**REVISED PERMIT MODIFICATION REQUEST
SECTION 311 PUB. L. 108-137/SECTION 310 PUB. L. 108-447
AND
REMOTE HANDLED WASTE**

The Carlsbad Field Office of the U.S. Department of Energy (**DOE**) and Washington TRU Solutions LLC (**Permittees**) are submitting this revised Permit Modification Request (**PMR**) to the Hazardous Waste Facility Permit (**HWFP**) for the Waste Isolation Pilot Plant (**WIPP**) in accordance with Permit Condition I.B.1 and 20.4.1.900 New Mexico Administrative Code (**NMAC**) which incorporates Title 40 Code of Federal Regulations (**CFR**) Section 270.42.

Figure 1 WASTE STREAM APPROVAL PROCESS

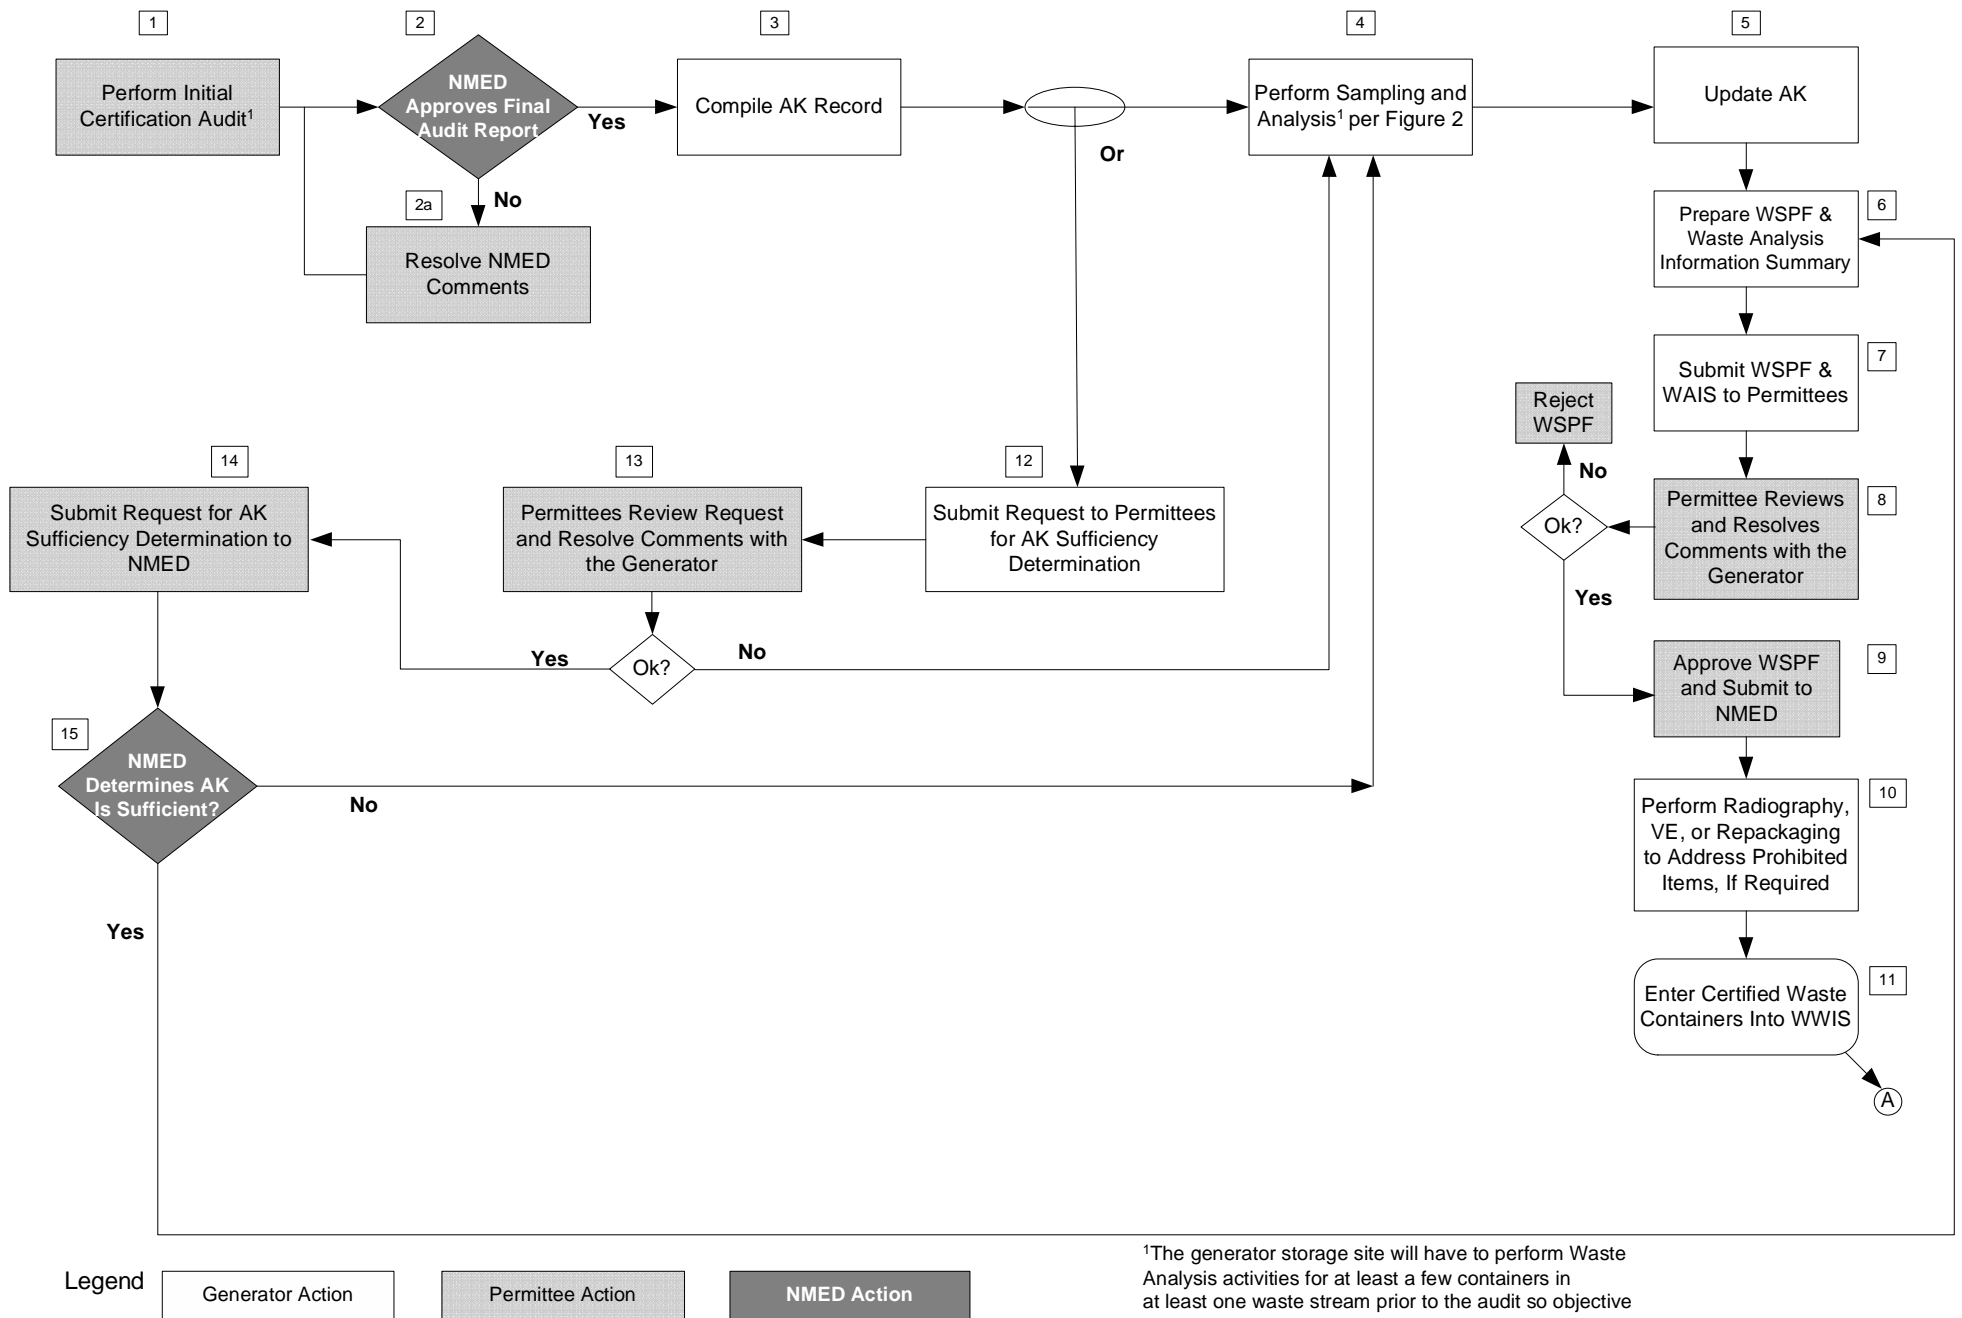
In response to NMED's comments, the revised PMR proposes two alternative pathways that the Permittees may follow for waste approval. Both pathways require the generator/storage sites to compile the AK information into an auditable record for the waste stream. The sampling and analysis pathway requires the generator/storage site to perform sampling and analysis on a representative portion of the waste stream. The AK sufficiency determination pathway applies to those waste streams that the Permittees determine have sufficient AK information to satisfy the TSDF-WAC (e.g., to assign HWNs). For these waste streams, the Permittees may request an AK sufficiency determination from NMED. If NMED determines that the AK is sufficient, the waste may be shipped to the WIPP facility without further representative sampling and analysis. If NMED determines that AK is not sufficient, or when the Permittees do not submit an AK

sufficiency determination request, additional waste analysis (i.e., Headspace Gas Sampling and Analysis [**HSGSA**] and Solids Sampling and Analysis [**SSA**]) will be performed on a representative portion of the waste stream. These generator/storage site waste analysis requirements are described in Section 1.2.1 below. See Figure 1, Waste Stream Approval Process.⁴

Figure 2 APPROACH FOR SOLID AND HEADSPACE GAS SAMPLING AND ANALYSIS TO OBTAIN SUPPLEMENTAL WASTE ANALYSIS INFORMATION

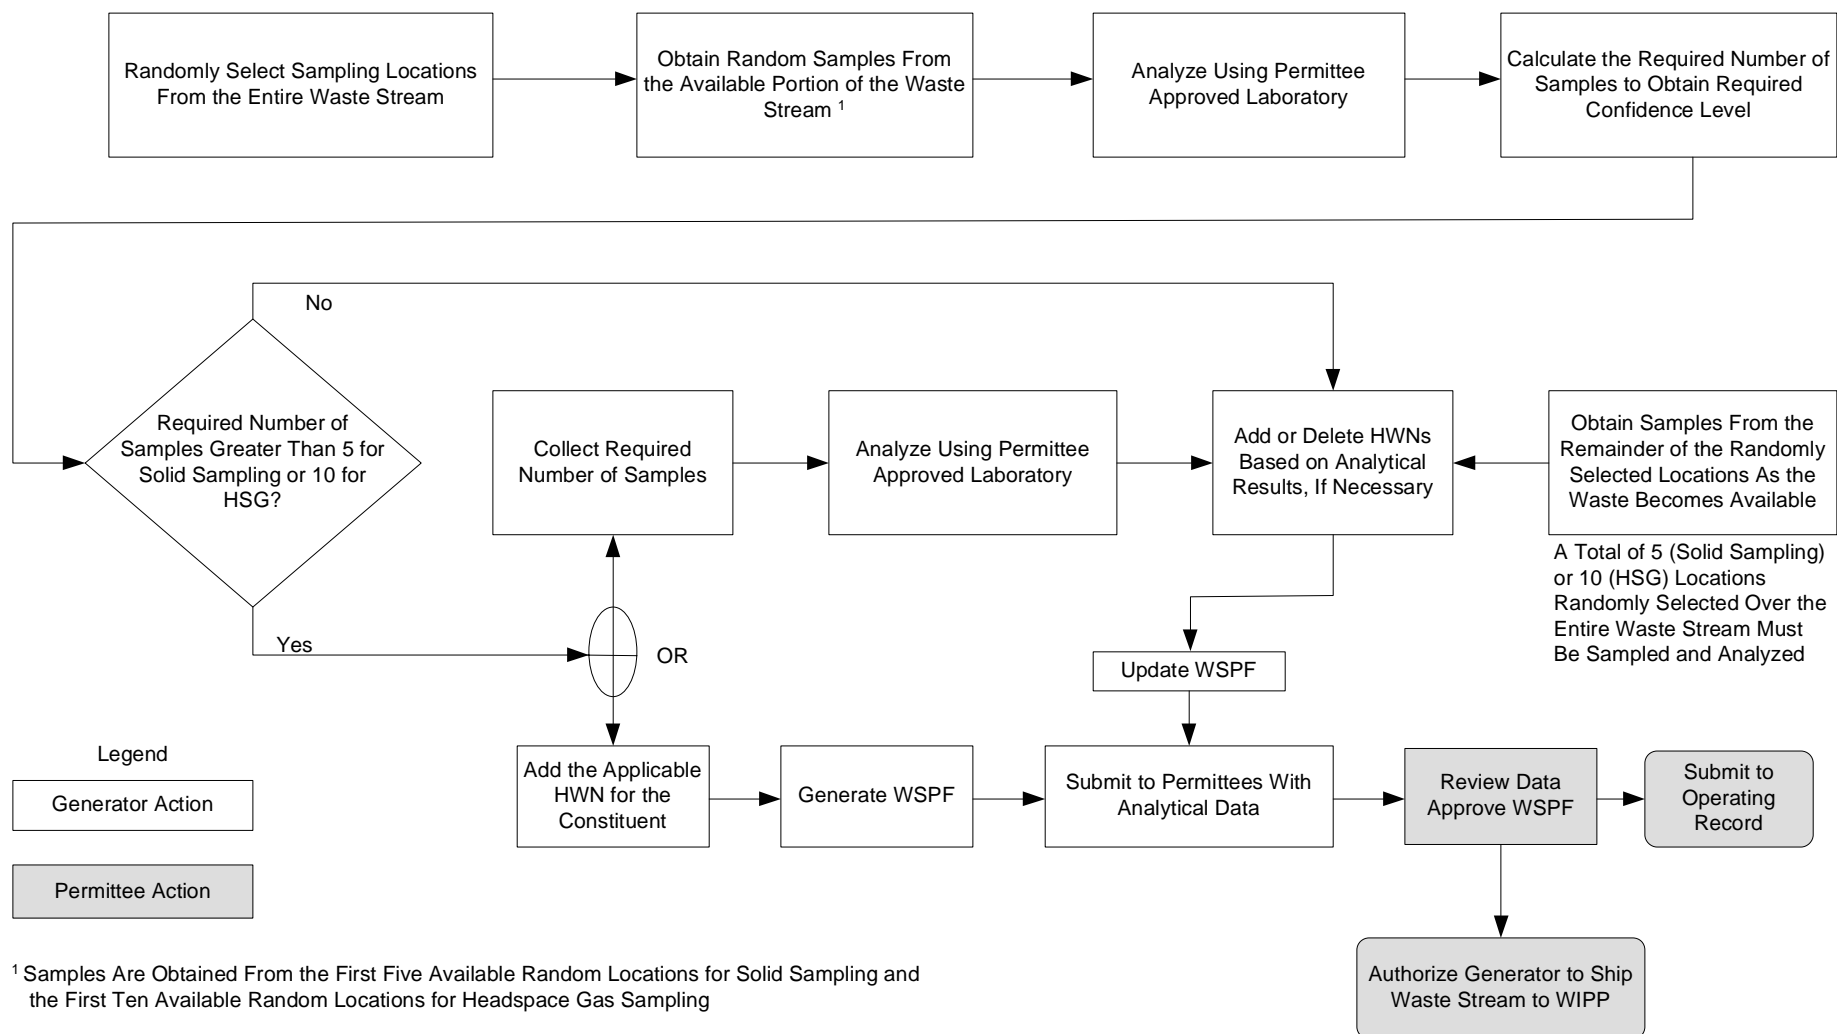
As discussed in Section 1.2, above, the PMR proposes two pathways for waste stream approval. The sampling and analysis pathway requires the generator/storage site to perform representative sampling and analysis of the waste stream after the AK record is compiled. Headspace gas sampling and analysis may be performed on debris waste. Solids sampling and analysis may be obtained for homogeneous solid or soil/gravel waste streams. The available portion of the waste stream would be randomly sampled and analyzed prior to completion of the WAIS and WSPF. The generator/storage sites would be required to follow the waste sampling methods in HWFP Attachment B1, the statistical methods in HWFP Attachment B2, and the quality assurance objectives (**QAOs**) and data validation techniques in HWFP Attachment B3. See Figure 2, Approach for Solid and Headspace Gas Sampling and Analysis to Obtain Supplemental Waste Analysis Information.

Figure 3 WASTE VERIFICATION and EXAMINATION PROCESS

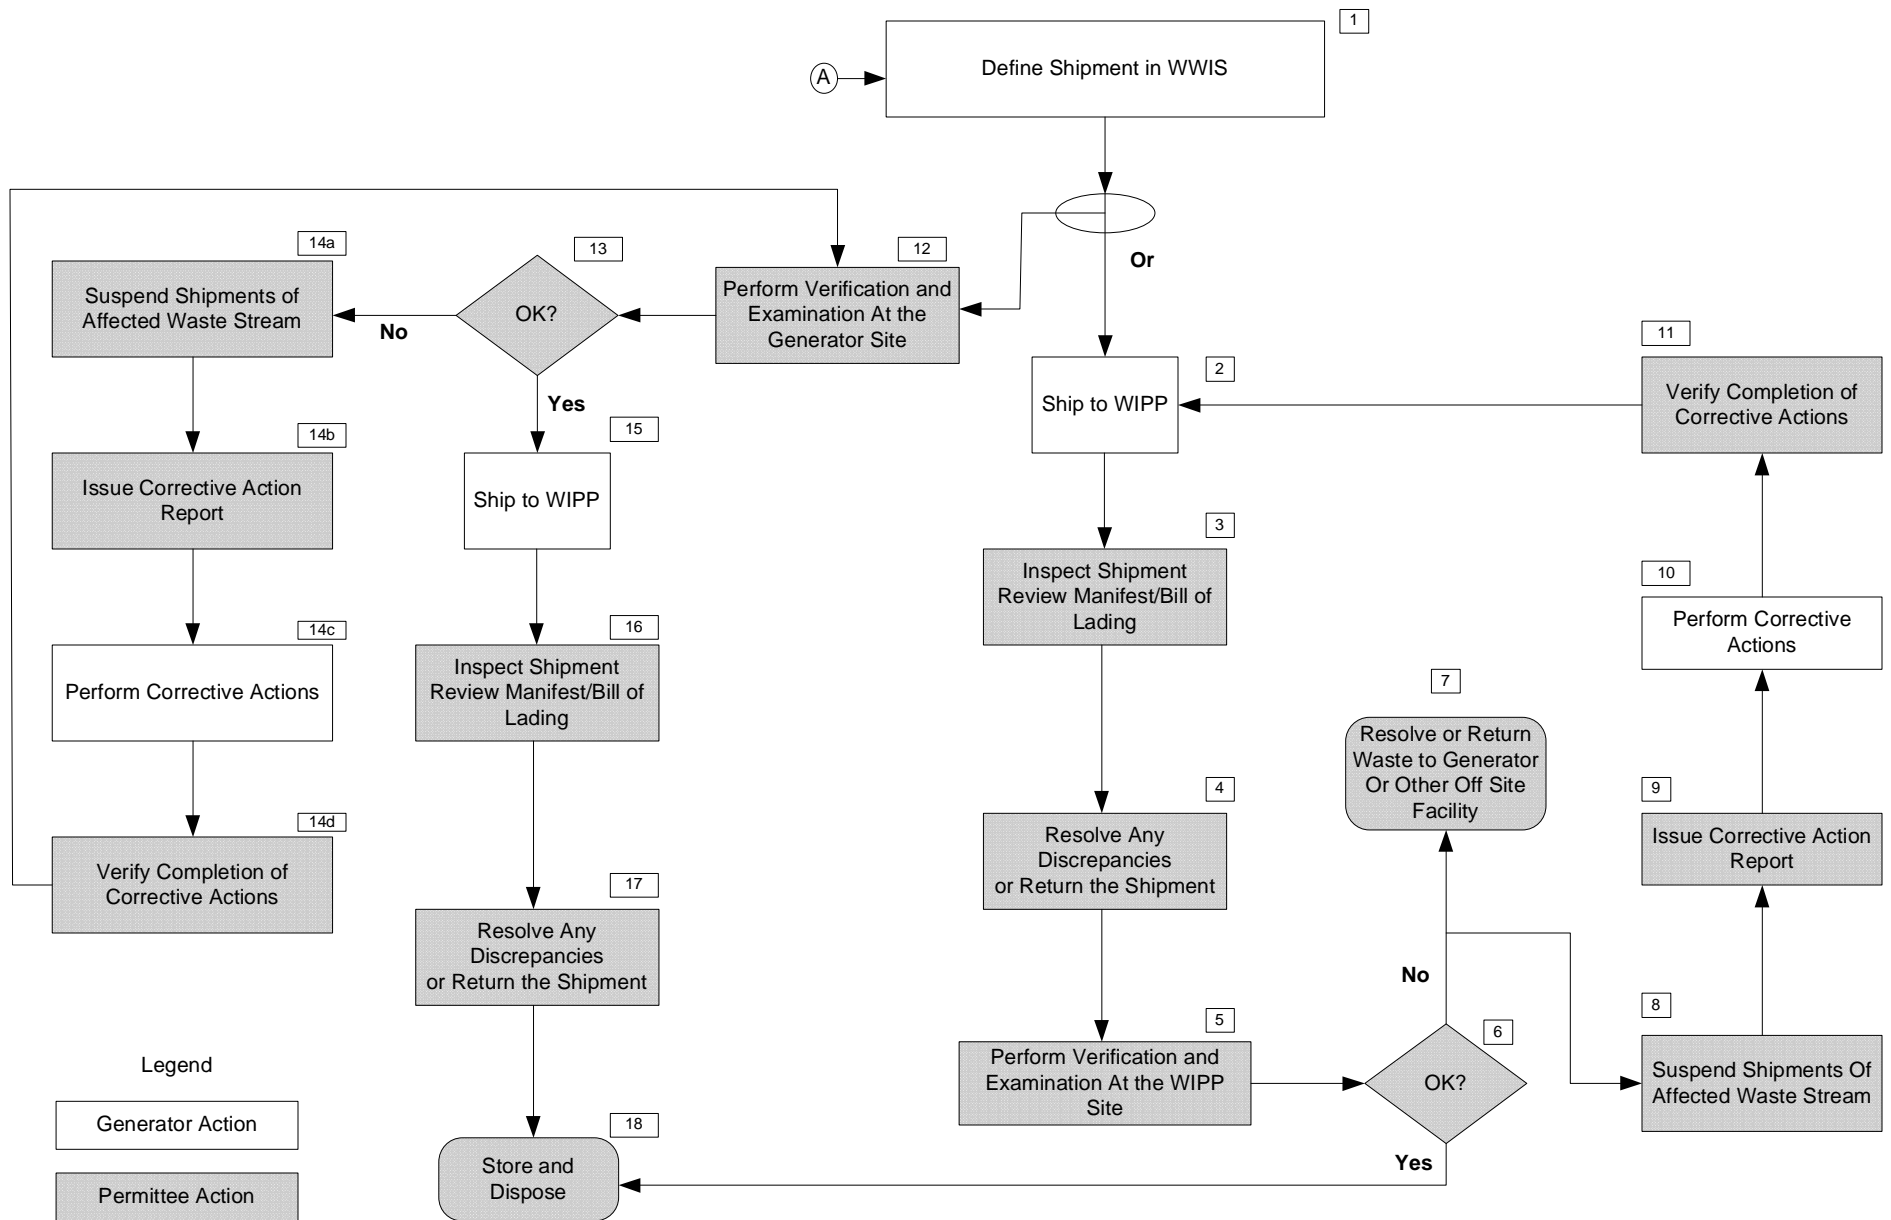
The revised PMR proposes the following Permittee level waste analysis processes: 1) waste stream screening and verification, including verification that the assigned HWNs are allowed for storage and disposal by the HWFP; 2) the use of radiography, visual examination (VE), or the review of VE records to verify that the waste contains no ignitable, corrosive or reactive waste; and 3) an audit and surveillance program. The Permittees will conduct radiography, VE, or the review of VE records of a statistically representative subpopulation of the waste either at the WIPP facility or at the generator/storage site. See Figure 3, Waste Verification and Examination Process; Figure 4, Verification and Examination Process at the Generator/Storage Sites (or Other Off-Site Facilities); Figure 5, Verification and Examination Processes at WIPP.

Figure 4 VERIFICATION and EXAMINATION PROCESS AT THE GENERATOR/STORAGE SITES
(OR OTHER OFF-SITE FACILITIES)

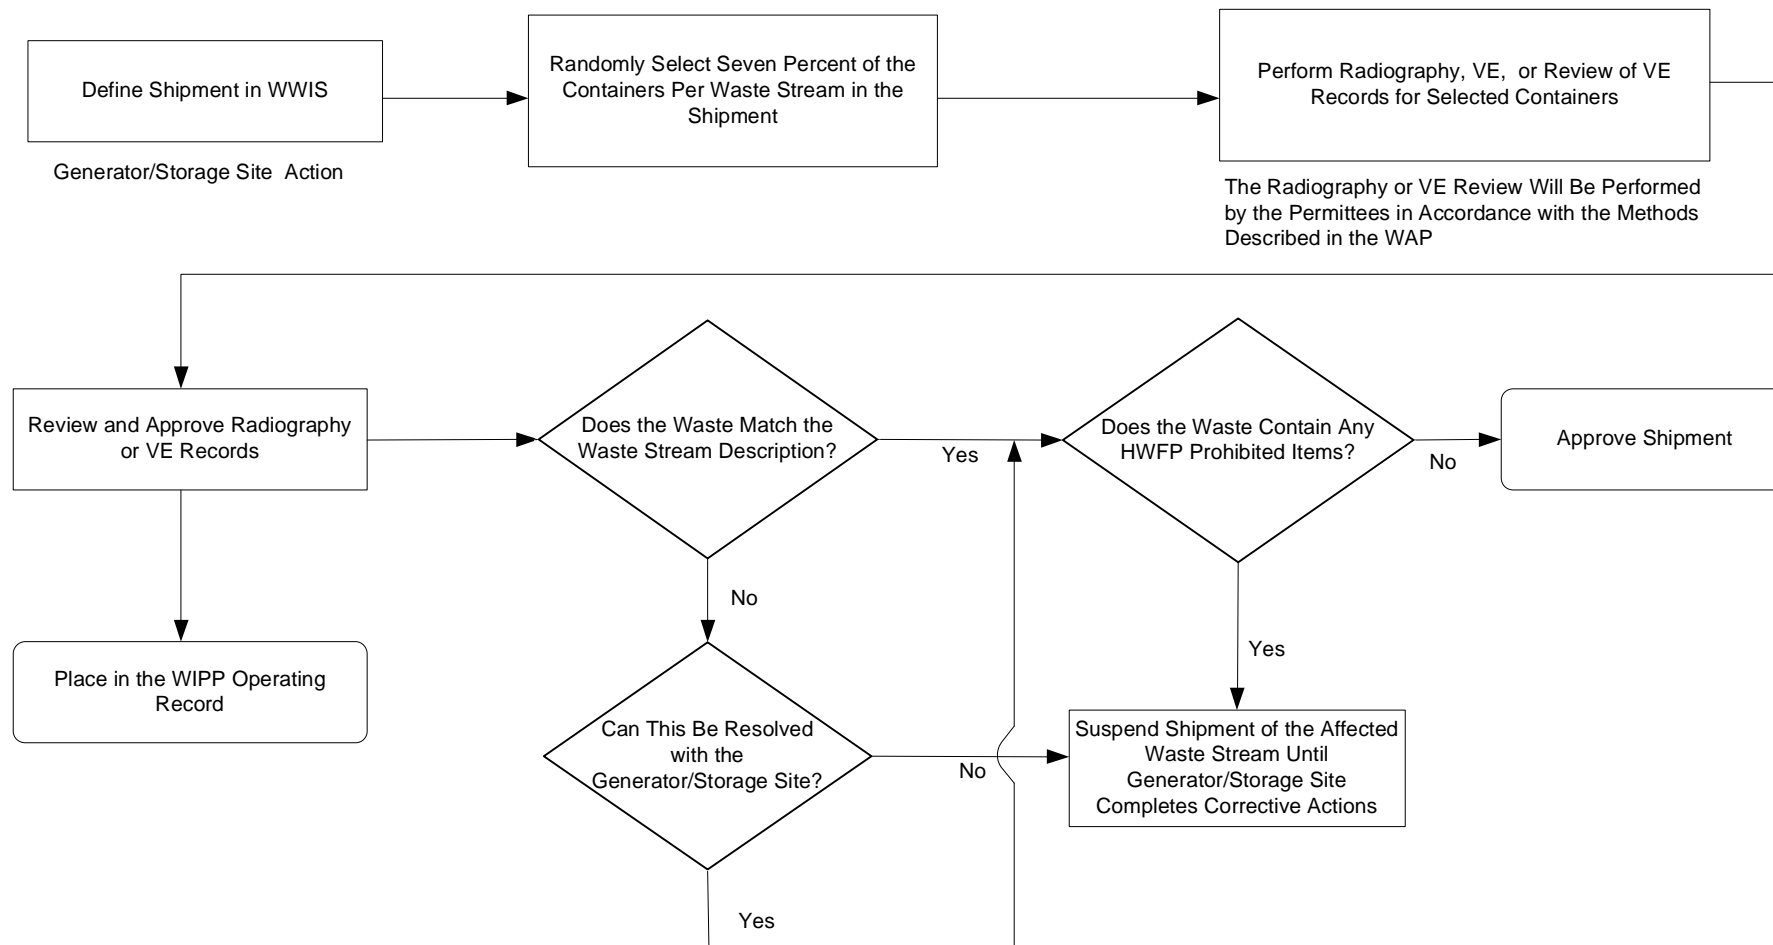
Generator/storage site waste examination may be used when the generator/storage site is shipping containers that cannot be radiographed at WIPP. For example, if the generator/storage site is placing 55-gallon drums into TDOPs, radiography will occur prior to packaging into the TDOP because of the container size limitation for typical radiography units (drums or SWBs). Radiography at the generator/storage site may also be used by the Permittees. Waste that is examined by the Permittees at the generator/storage sites may be placed into permitted storage areas once container integrity and identification numbers are verified.
